Planning Commission Staff Report

Project Type: Amended Sign Package

Description: **One Chesterfield Place, Amended Sign Package:** A request to amend a Sign Package for One Chesterfield Place, a 6.44 acre tract of land located on the north side of North Outer 40 Road and west of Timberlake Manor.

Figure 2: Front Building Façade

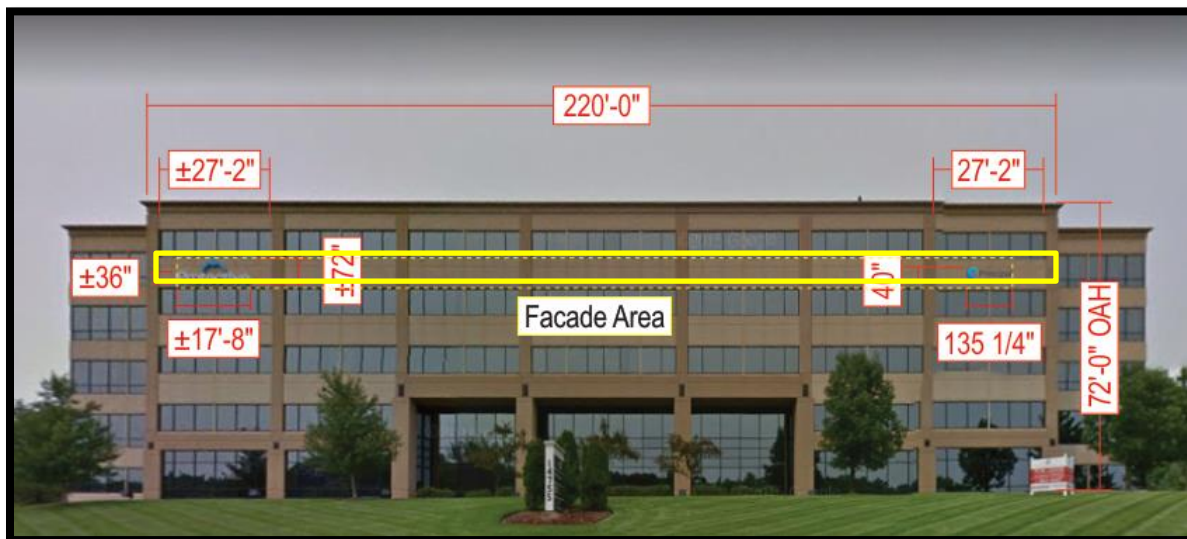
Specifically, the request is to permit two wall signs that shall not exceed five (5) percent of the front façade or a maximum of 300 square feet. The signs shall be placed in the sign band (outlined in yellow in Figure 2) between the 4th and 5th floors and shall be centered between brick masonry pilaster columns on the far left and far right window banks. Neither sign shall individually exceed 150 square feet.

The proposed wall signs fit well into the building design and are consistent with the wall signs on the adjacent parcel to the west, the Highland on Conway development. The centering of the signs between

two brick masonry pilaster columns on the brick masonry band between the 4th and 5th floors of the building limits the maximum height of any sign to 6 feet tall and provides a clear frame for the proposed signs.

The combined size of the two requested wall signs does not exceed the UDC and governing ordinance size limitation of five (5) percent of the area of the façade (with no sign to exceed 300 square feet). Further, limiting the signs to the southern façade would ensure that the adjacent residential neighborhood situated to the north would not be impacted by signage in the future.

Figure 3: Rose International Building at 16401 Swingley Ridge Road

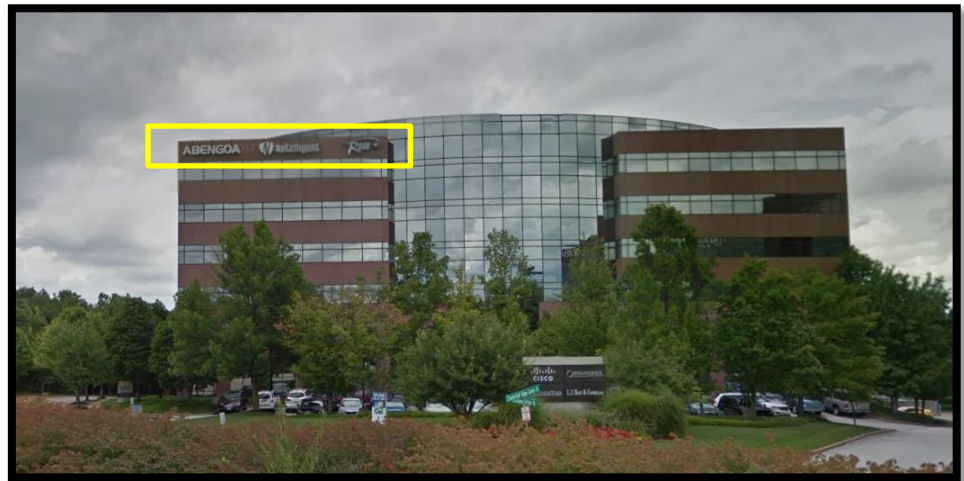
The City of Chesterfield does not regulate the content of signage. An applicant is permitted to place signs near each other in order to comply with the five (5) percent regulation in the Unified Development Code, such as in the example shown in Figure 3 below of the Rose International Building, located at 16401 Swingley Ridge Road.
